The 4302 7th Avenue NE site is located in the vibrant University District NW Urban Center Village. It is predominantly populated by students and faculty of the University of Washington. The project team seeks to design a 4 story above grade 47-unit multi-family apartment building with 11 below grade parking spaces.

At the Third Early Design Guidance Meeting, the Board suggested locating the south interior exit stair door off the “patio”. The stair will probably be heavily used as circulation by the many of the tenants. See Guideline A-4.

SOUTH ELEVATION
NO SCALE

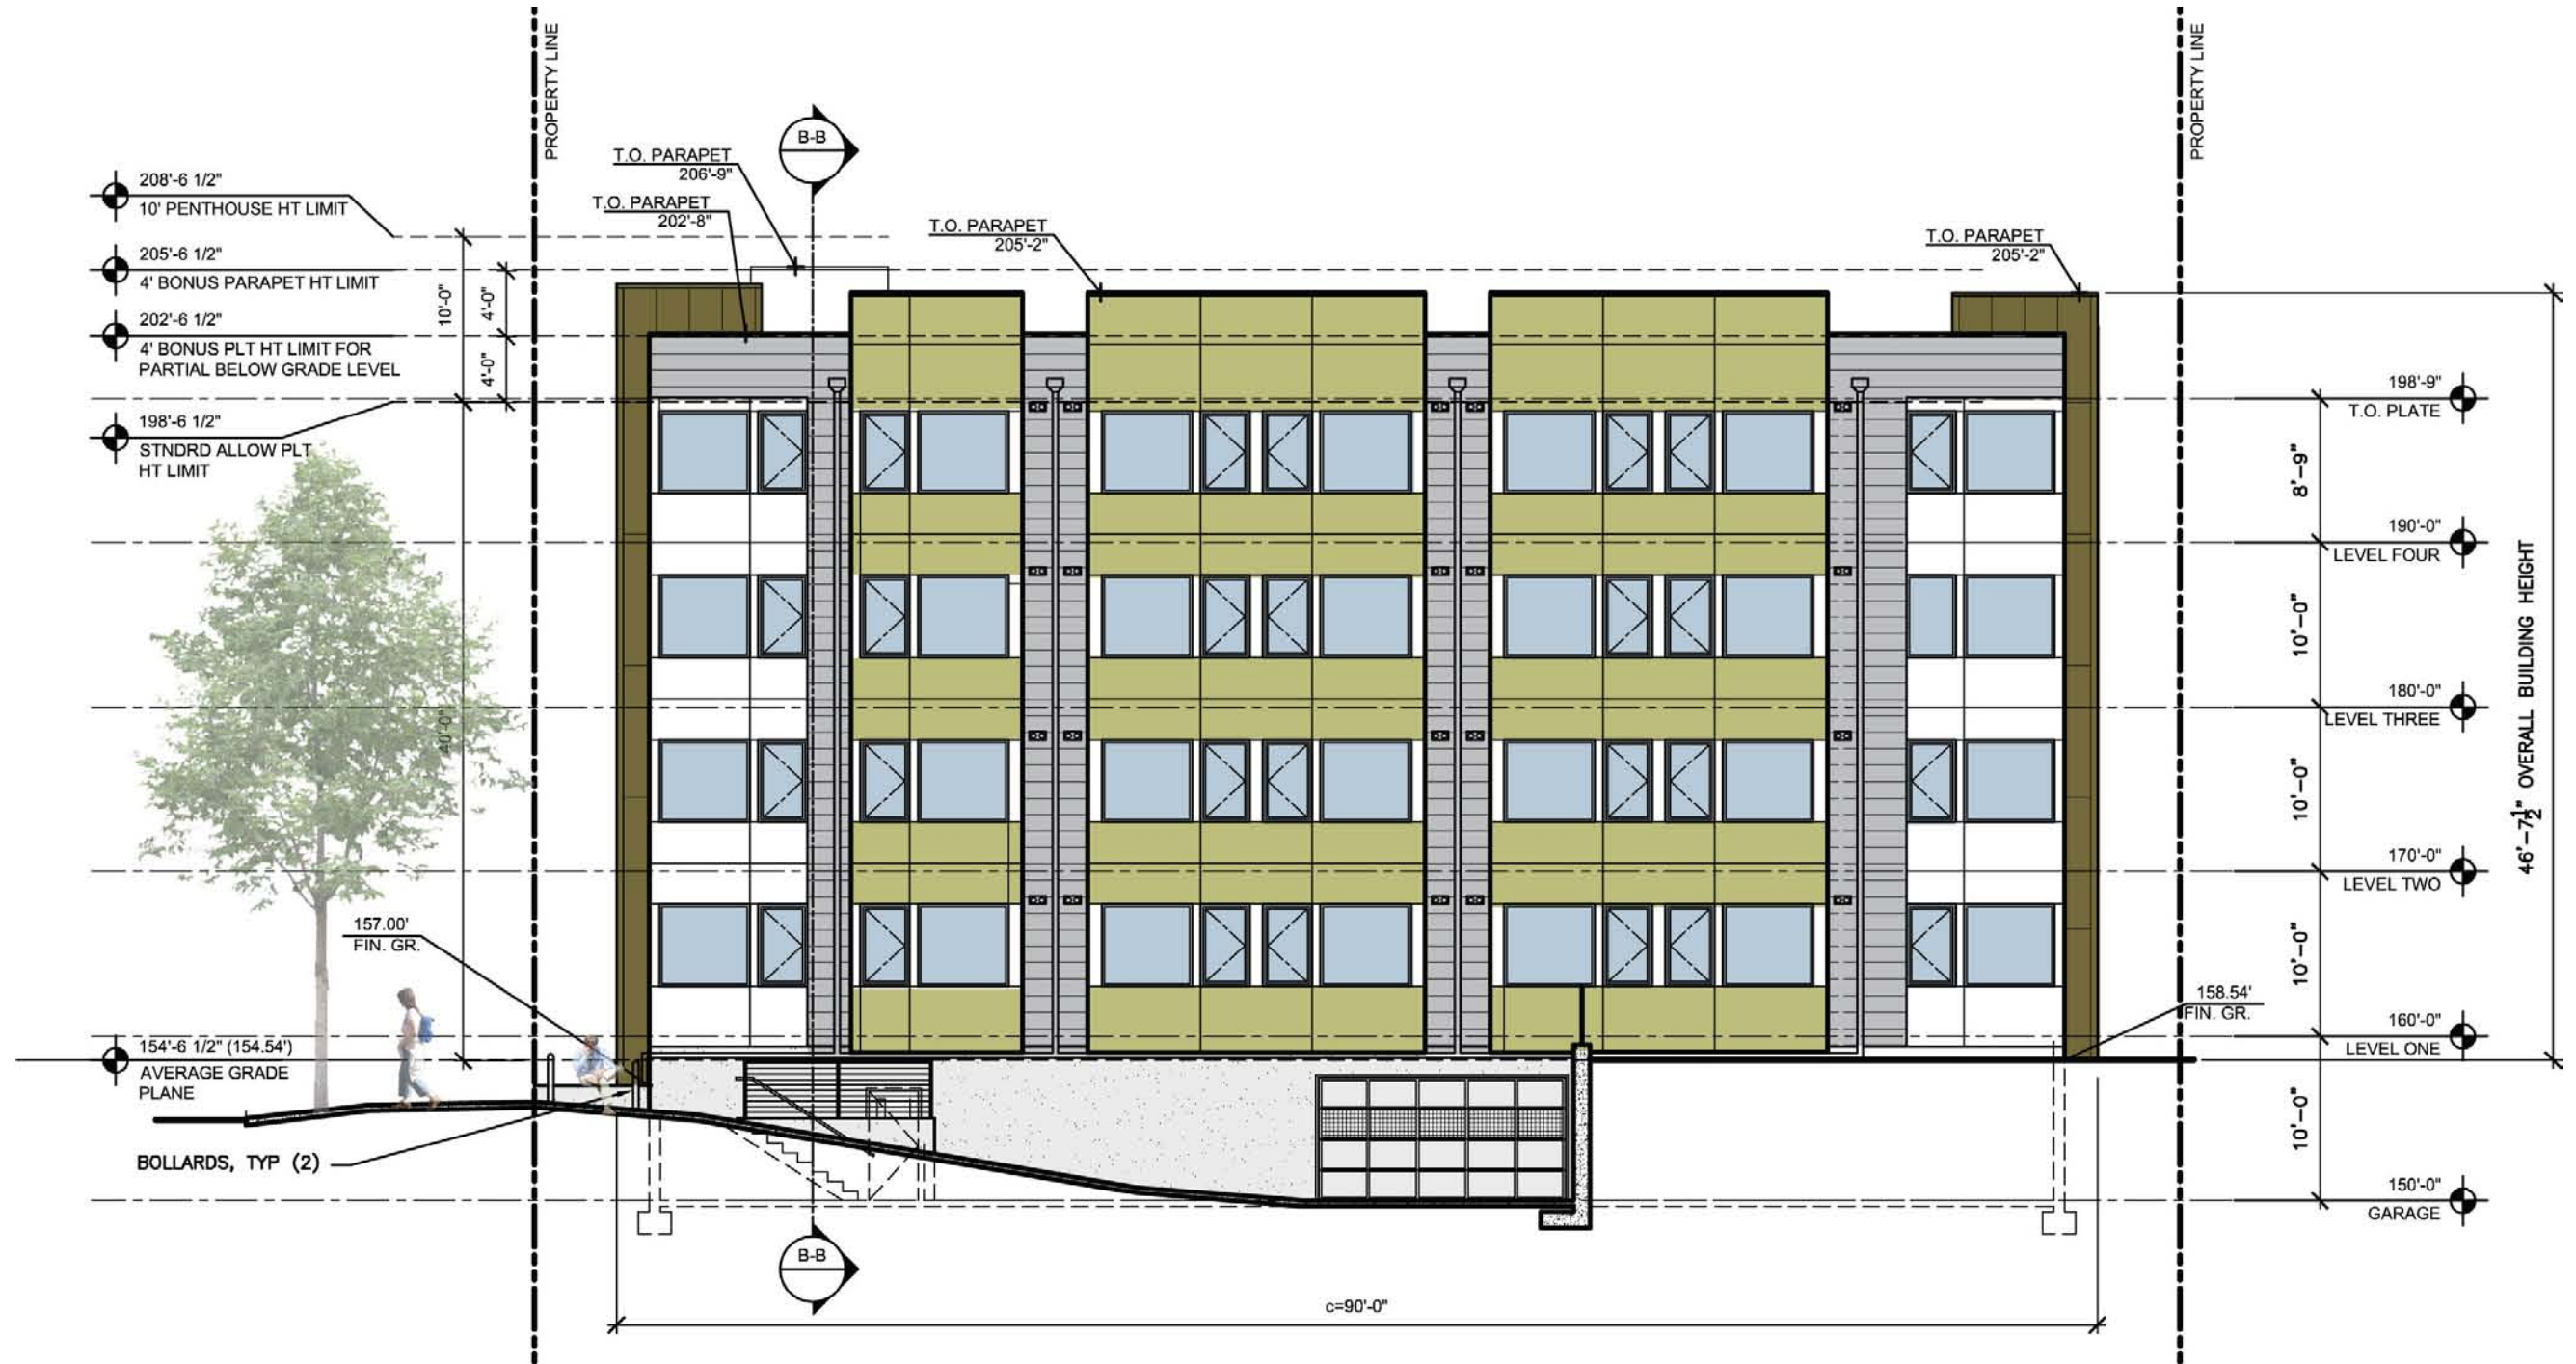
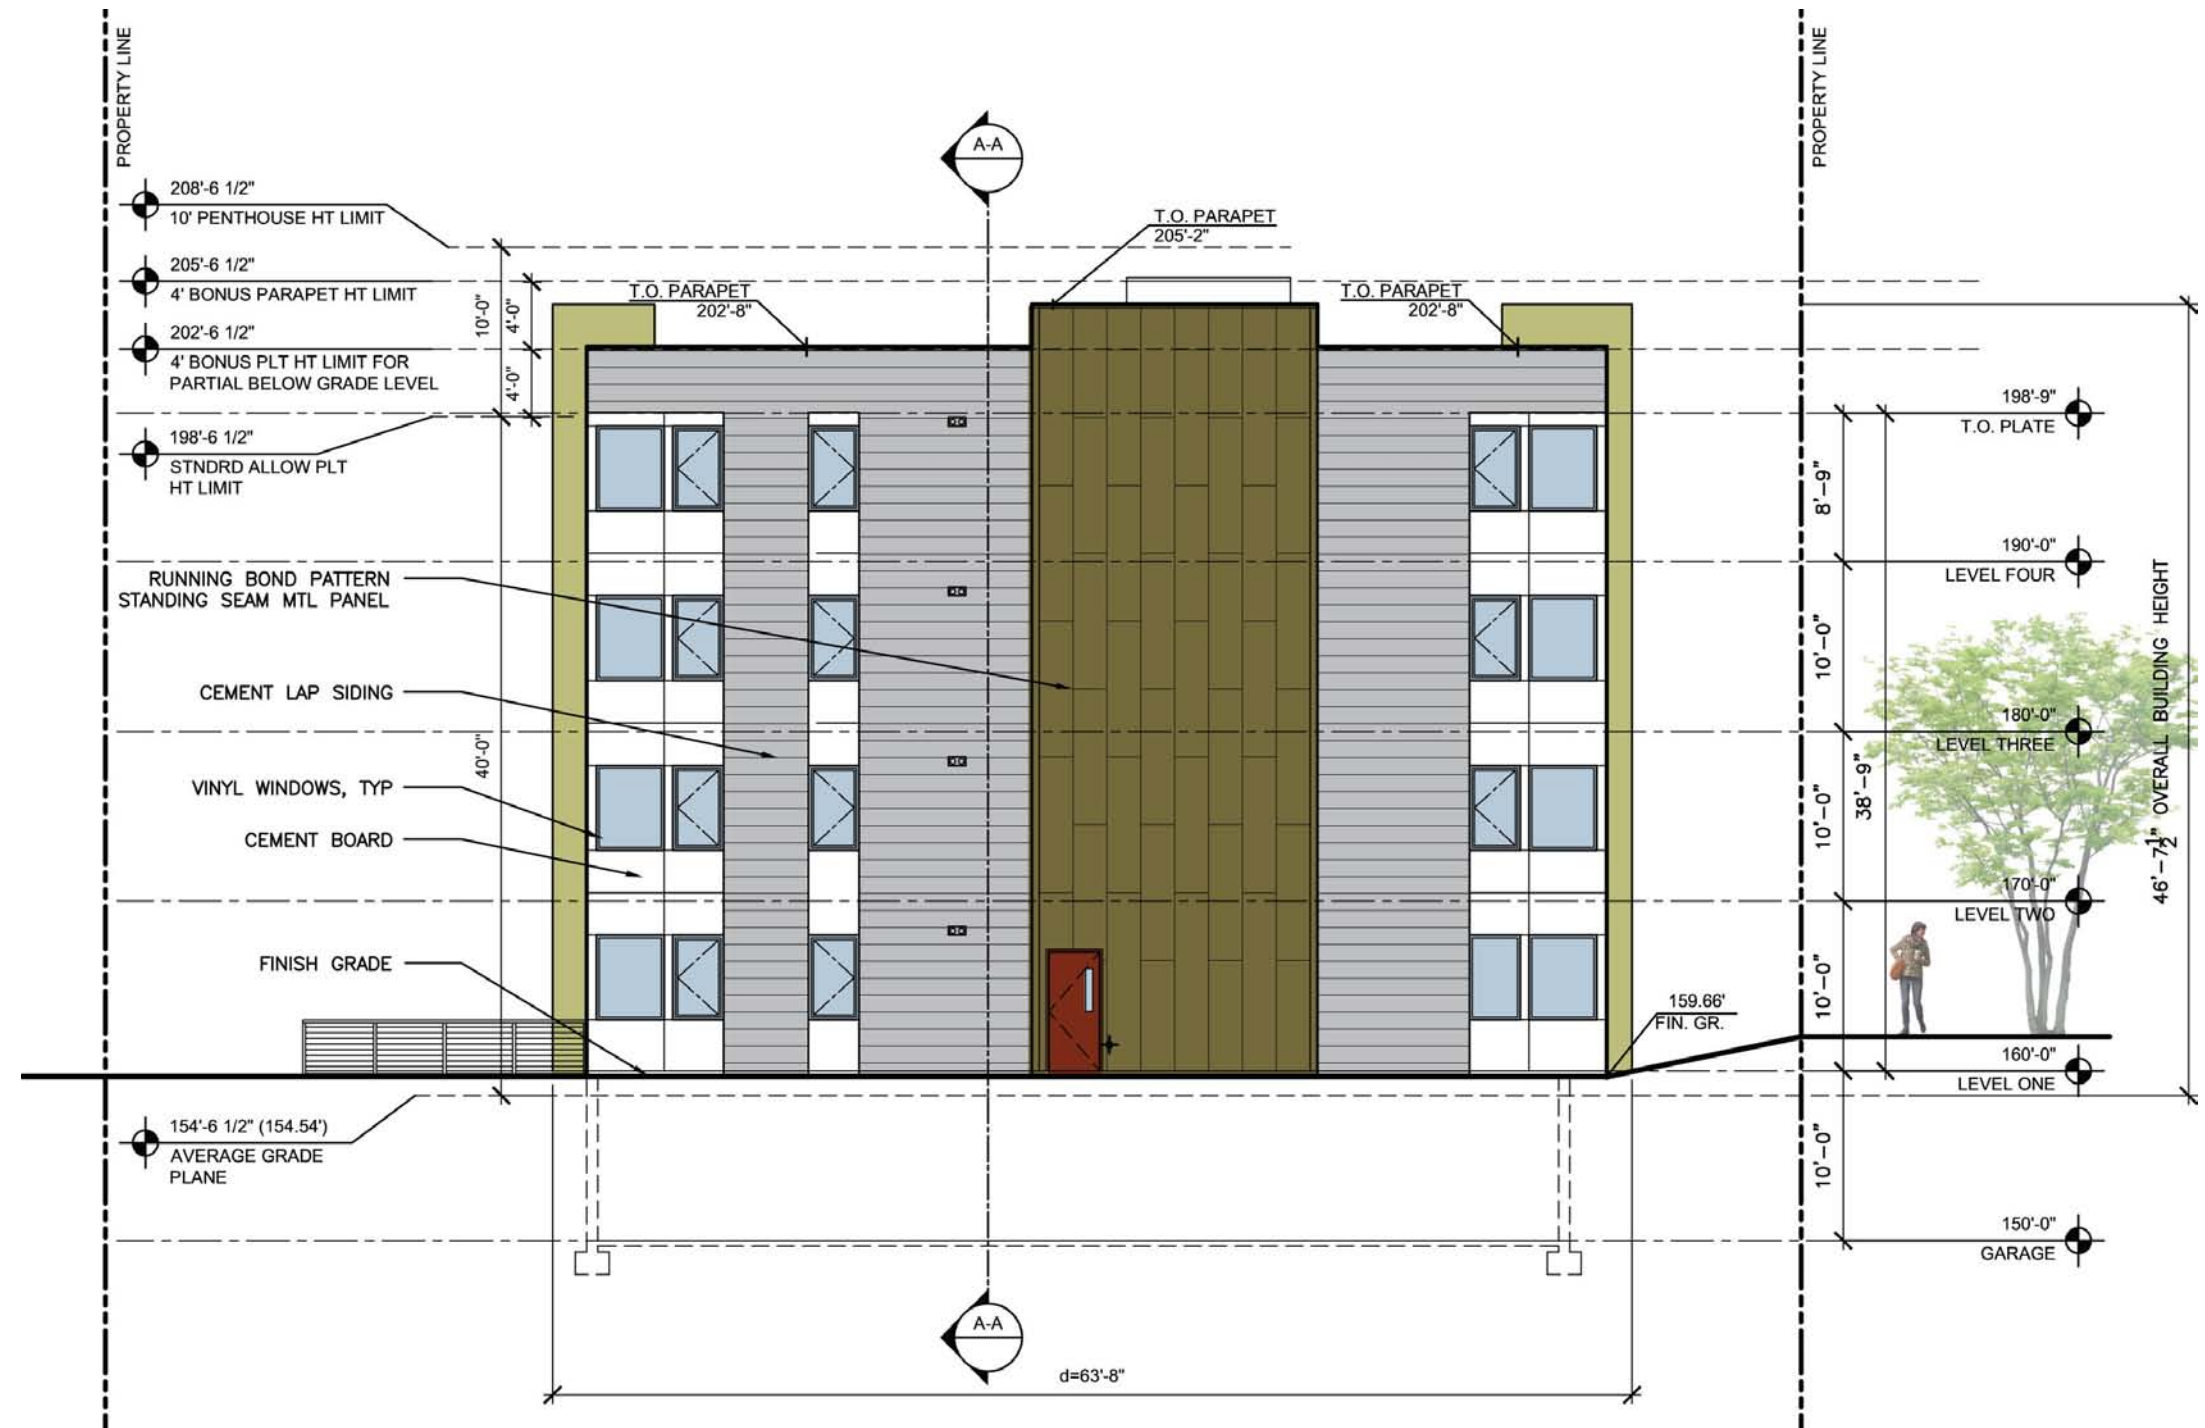
At the Third Early Design Guidance Meeting, the Board expressed concern about the amount of blank walls and service uses oriented along 43rd Ave NE. Most pedestrian traffic is expected along 43rd. The south interior exit stair towers should provide windows to break up the blank facade. Consider shifting the south stair to provide window access into interior circulation corridor.

Response: The enclosed staircase has been redesigned as an open exterior staircase. The open stair also allows for visibility from the street and for glazing in the exit doors which permits natural light into the hallways. A planter at the base and a painted metal grid will provide a structure for a green wall that will add to the texture and interest of the stair. The landing and tread material will be steel bar grating that allows for visibility for security.
